Professional Audio Service Bulletin

Mincom
Division **3M**
COMPANY

SUBJECT: Signal Electronics PC Board FET Replacement

FIGURE 1

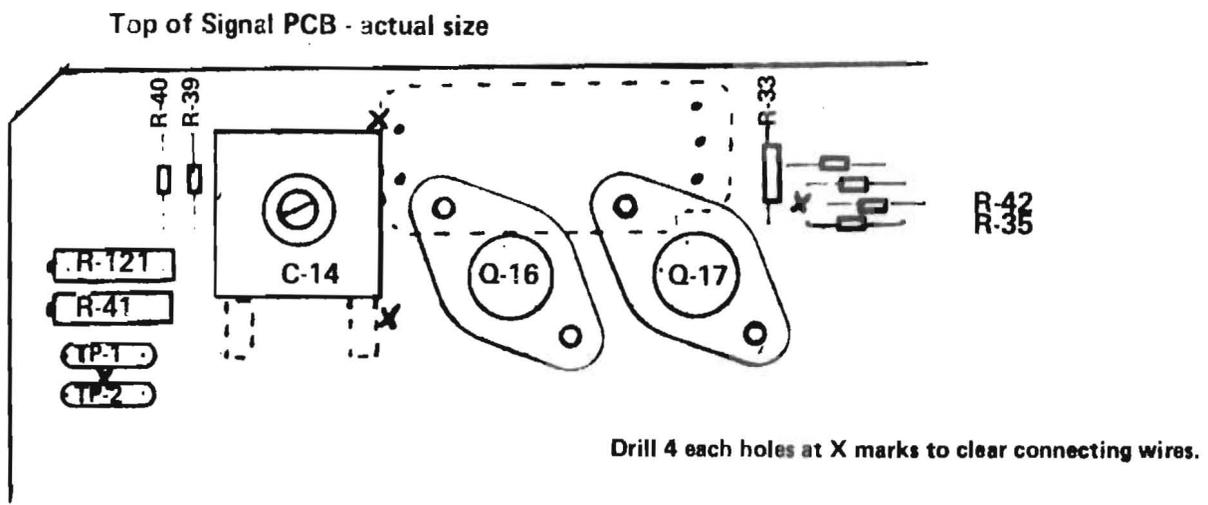
1. Remove Q-20, R-13, R-19, CR-9 and discard.
2. Remove any jumper connected to points E-10 through E-13.
3. Remove TP-2 (white) from board. Use care in not lifting pads from pc board (see figure 1).
4. R-41-A will be mounted in place of TP-2. Clip off rear lead of R-41-A. Drill a hole midway between and slightly above TP-2 mounting holes. This hole and forward most hole will be used to mount R-41-A (see figure 1).
5. Locate trace running from R-42 to wiper of R-41. Cut this trace about an inch from R-42.
6. Drill a hole behind bottom lead of C-14 (erase trimmer). Do not drill through any traces.

7. Locate same trace as in Step 5 and drill a hole into this trace between C-14 and Q-16 (see figure 1).
8. Mount relay K-A on a piece of perf board and mount the perf board to the mounting screws of Q-16 and Q-17 using two 6-32 nuts (see figures 1 and 2).

FIGURE 1

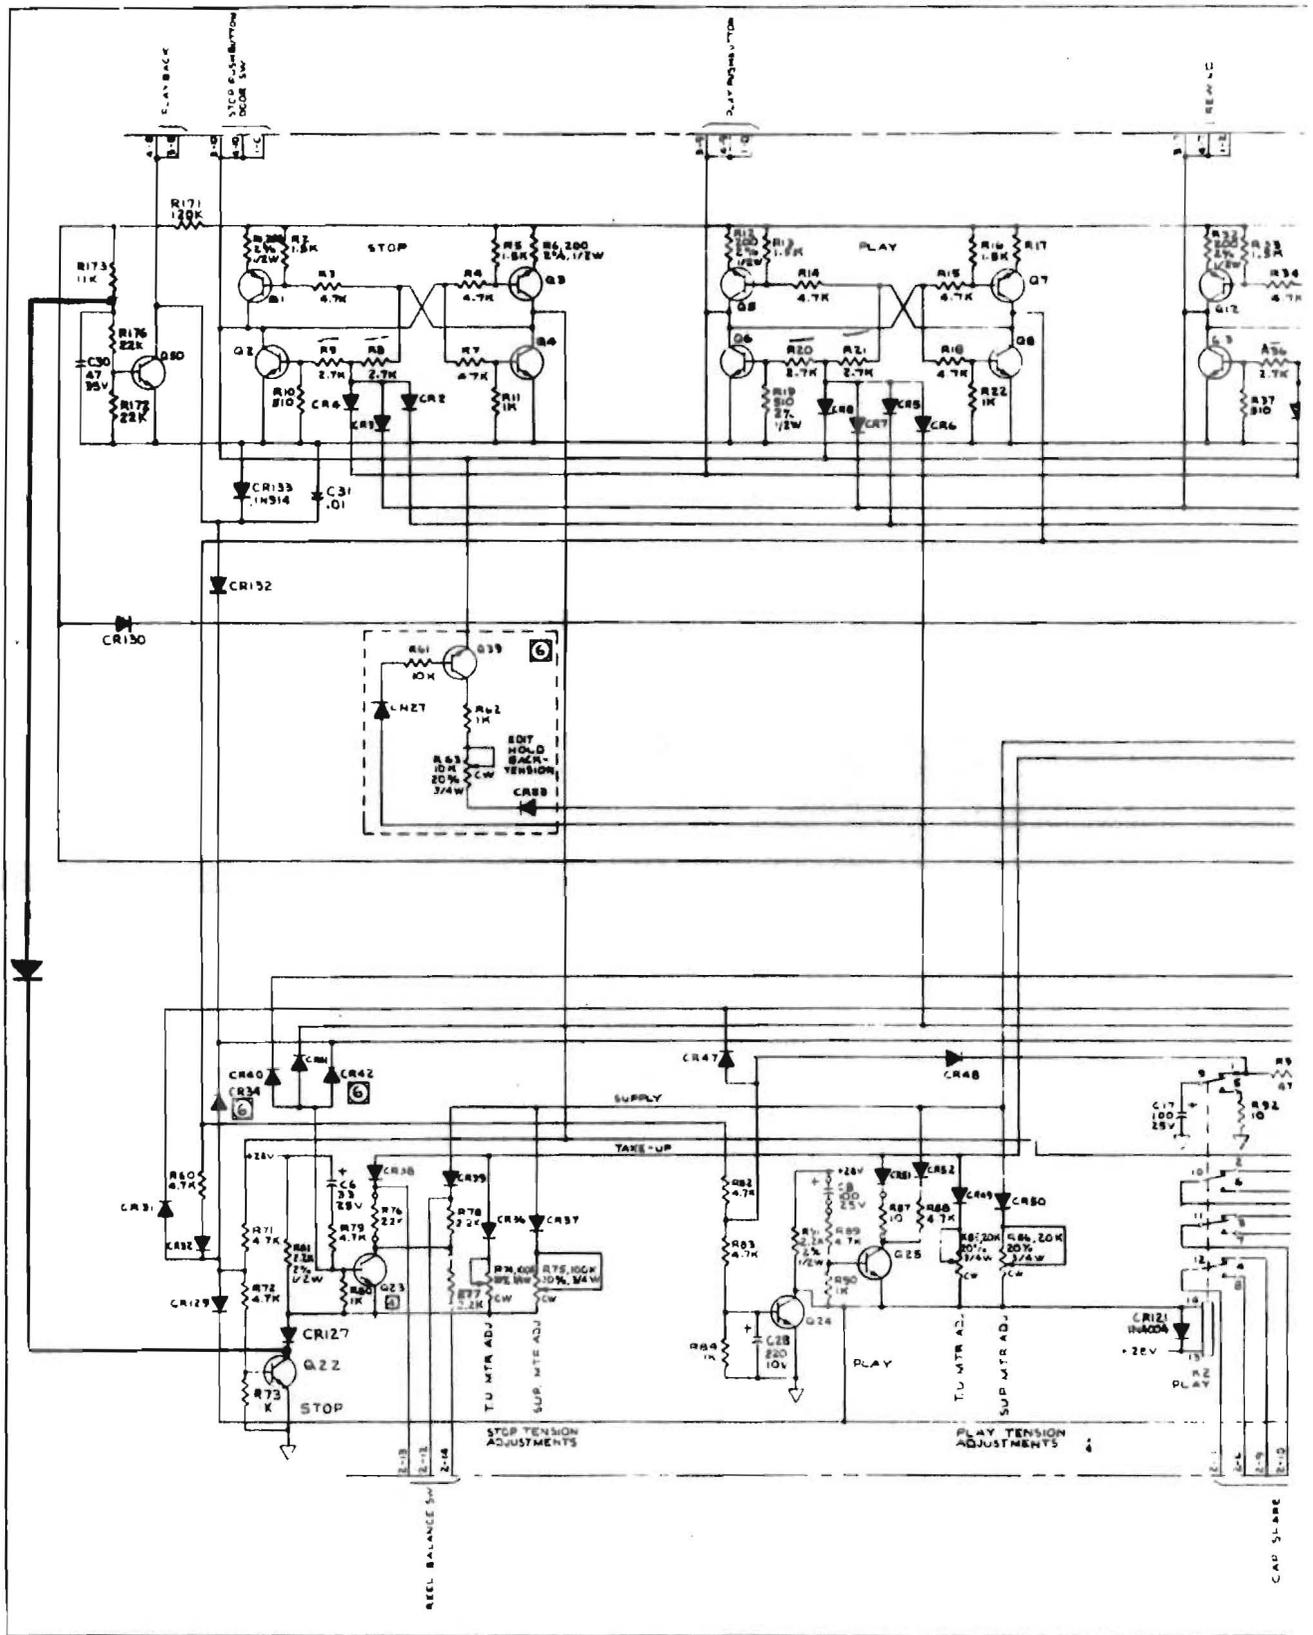
- 1) Remove logic pc Board from recorder.
- 2) Install 1N914 diode from collector of Q-22 to junction of R-173 and R-176. (cathode of diode to collector of Q-22) see Fig. 1. Use tubing on leads of diode.
- 3) Install logic pc board into recorder.
- 4) Thread a roll of tape onto the recorder which has a signal recorded on it and press stop button.
- 5) Manually move tape back and forth. Signal from tape should not be heard nor appear on meters.
- 6) Press mute defeat switch and repeat step five. Signal should be heard and should appear on meters.
- 7) This mod will not effect the monitoring of input signals.

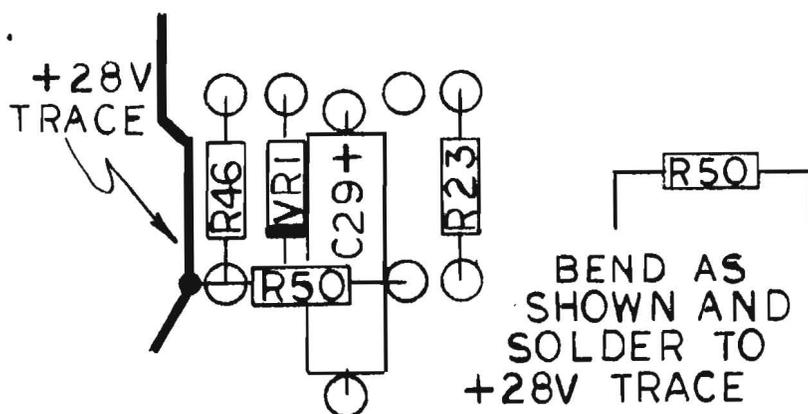
1. Remove R50.
2. Install 20K ohm resistor as shown in figure 1.

Fig. 4

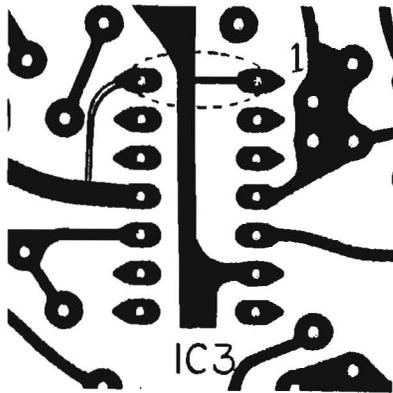
- 6. Using Mylar sleeving over cap leads; solder .02uF cap to traces from IC3 pins 6 and 11. See Figure 4, below.
- 7. Using Mylar sleeving over cap leads; solder .02uF cap to traces from IC4 pins 6 and 11. See Figure 5, below.

Figure 1

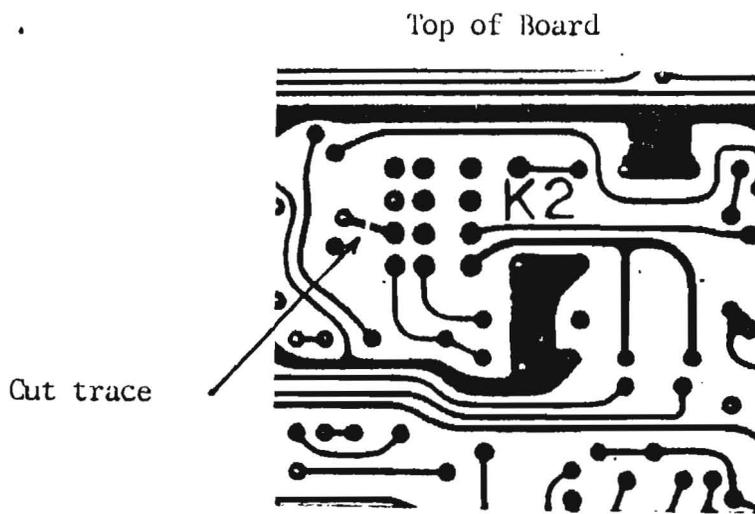
- SUBJECT: Modification of Capstan Braking Circuit
- APPLICABLE TO: All M-79 Logic Boards
- PURPOSE: To prevent possible failure of Q6, the Capstan Servo drive transistor.
- PROCEDURE:
1. Remove power from the M-79.
 2. Remove the logic board.
 3. Cut the trace from K2-2 to J2-8. See Figure 1, below.

FIGURE 1

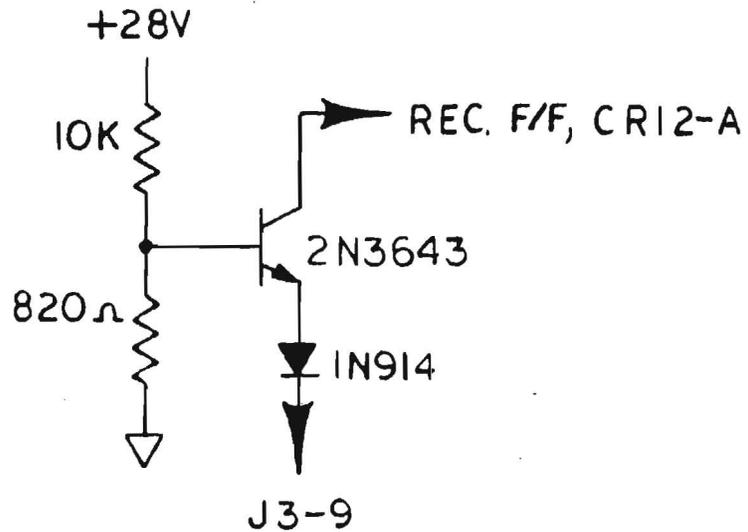
11. Remove Logic and Master Bias Supply board from rear of M79.
12. Add the circuit shown in Figure 1, below, to the Logic board.

FIGURE 2

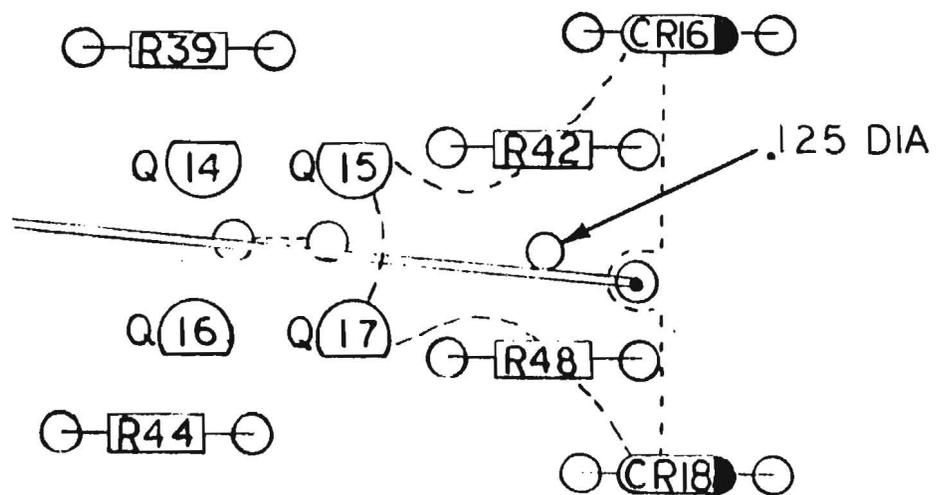
- a. Locate the ground plane between R42 and R48 (lower left quadrant of Logic board), on the rear side of board. See Figure 2, below.
- b. Drill .125 Dia. hole through ground plane, ensuring that hole does not cut any traces on component side of board. See Figure 2, below.

FIGURE 3

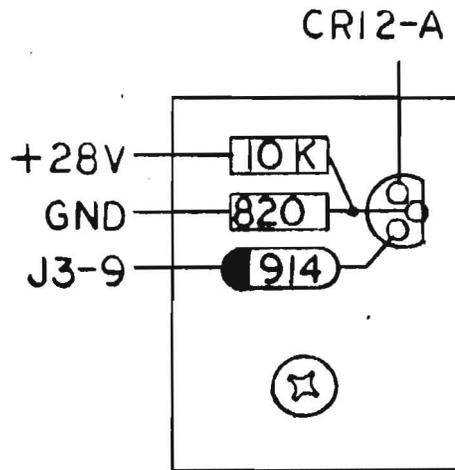
- c. Fabricate circuit shown in Figure 1, above, on 3/4" x 1" perf board, using Figure 3, below, as a guide.
